New Gen III Cool Fuel Module

Models Affected

All MerCruiser sterndrive and inboard engines equipped with Gen III cool fuel systems.

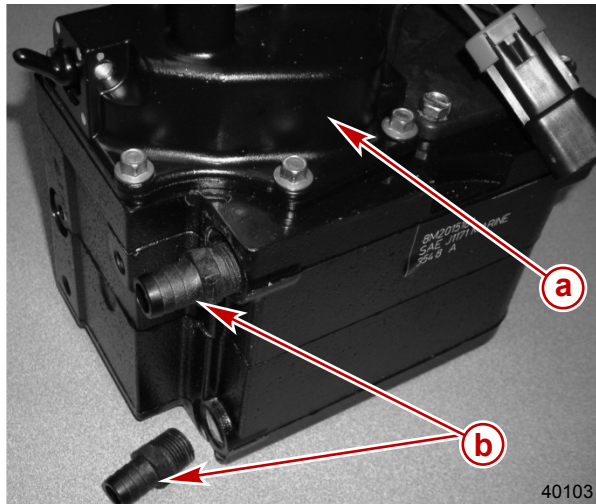
A new Gen III cool fuel module is being introduced to replace the existing Gen III module. Engines with serial numbers above the range listed are equipped with the new module from the factory. The primary difference between the designs is the method of connecting the cooling water hoses to the module. Refer to the Mercury Electronic Parts Catalog (EPC) for replacement modules for engines with serial numbers above the ranges listed.

The new style module will replace any older style module for service needs. In order to use the new module on earlier applications, the cooling water hoses and various fittings must be replaced. Kits are available to accommodate the various possible hose configurations. Order the Gen III Cool Fuel Module with pumps and filter, or a lower module housing only along with the proper hose kit for installation. One module and one kit are required per engine.

Replacement kits	
Complete Gen III module with pumps and filter	864650A13
Lower Gen III module housing (no pumps or filter)	864650A14
Two bib hose kit	865317T02
Three bib hose kit	865208T02

- a** - Gen III cool fuel module
- b** - Barbed hose fitting

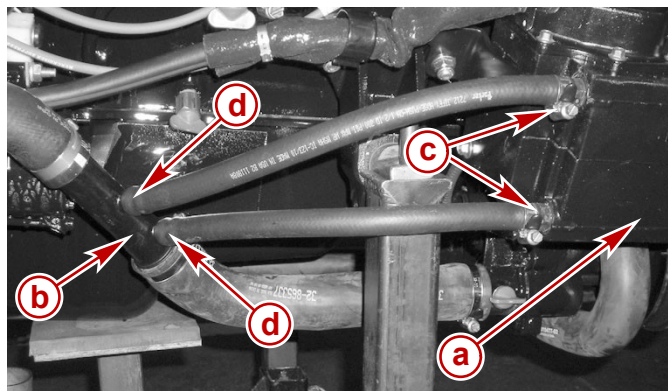
Threaded hose barb fittings are supplied with the new Gen III cool fuel module. The threads on the barbed hose fittings and the threaded bore must be coated with Perfect Seal. Any removal of the fitting will require resealing the threads. Refer to the instruction sheet with the module for additional installation information.
